## Product Change Notice (PCN)

PCN Number: **PCN-0451140R-01**

Product(s) Affected: PJ-035C

PREVIOUS CUI DEVICES DETAIL / IMAGE	NEW CUI DEVICES DETAIL / IMAGE

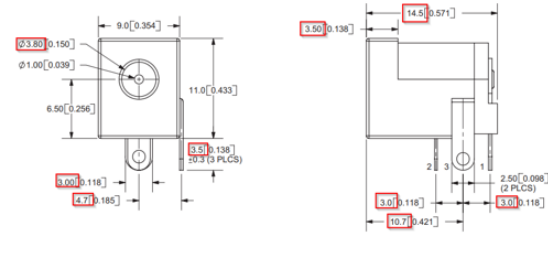
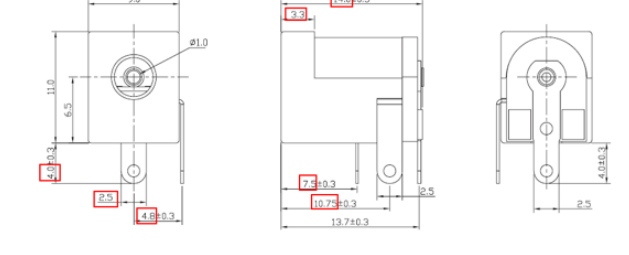
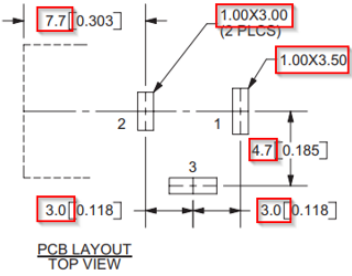
Description of Change: mechanical, and material differences as shown below:

<p>PCB LAYOUT TOP VIEW</p>	 <p>Recommended PCB Layout Top View</p>																																							
<table border="1"> <thead> <tr> <th></th> <th>MATERIAL</th> <th>PLATING</th> </tr> </thead> <tbody> <tr> <td>center pin</td> <td><b>copper</b></td> <td>nickel</td> </tr> <tr> <td>terminal 1</td> <td>brass</td> <td>tin</td> </tr> <tr> <td>terminal 2</td> <td><b>copper alloy</b></td> <td>tin</td> </tr> <tr> <td>terminal 3</td> <td>brass</td> <td>tin</td> </tr> <tr> <td>plastic</td> <td>PBT</td> <td></td> </tr> </tbody> </table>		MATERIAL	PLATING	center pin	<b>copper</b>	nickel	terminal 1	brass	tin	terminal 2	<b>copper alloy</b>	tin	terminal 3	brass	tin	plastic	PBT		<table border="1"> <thead> <tr> <th>DESCRIPTION</th> <th>MATERIAL</th> <th>PLATING/COLOR</th> </tr> </thead> <tbody> <tr> <td>center pin</td> <td><b>brass</b></td> <td>nickel</td> </tr> <tr> <td>terminal 1</td> <td>brass</td> <td>tin</td> </tr> <tr> <td>terminal 2</td> <td><b>bronze</b></td> <td>tin</td> </tr> <tr> <td>terminal 3</td> <td>brass</td> <td>tin</td> </tr> <tr> <td>cover</td> <td>PBT (UL94V-0)</td> <td>black</td> </tr> <tr> <td>housing</td> <td>PBT (UL94V-0)</td> <td>black</td> </tr> </tbody> </table>	DESCRIPTION	MATERIAL	PLATING/COLOR	center pin	<b>brass</b>	nickel	terminal 1	brass	tin	terminal 2	<b>bronze</b>	tin	terminal 3	brass	tin	cover	PBT (UL94V-0)	black	housing	PBT (UL94V-0)	black

MATERIAL	PLATING																																						
center pin	<b>copper</b>	nickel																																						
terminal 1	brass	tin																																						
terminal 2	<b>copper alloy</b>	tin																																						
terminal 3	brass	tin																																						
plastic	PBT																																							
DESCRIPTION	MATERIAL	PLATING/COLOR																																						
center pin	<b>brass</b>	nickel																																						
terminal 1	brass	tin																																						
terminal 2	<b>bronze</b>	tin																																						
terminal 3	brass	tin																																						
cover	PBT (UL94V-0)	black																																						
housing	PBT (UL94V-0)	black
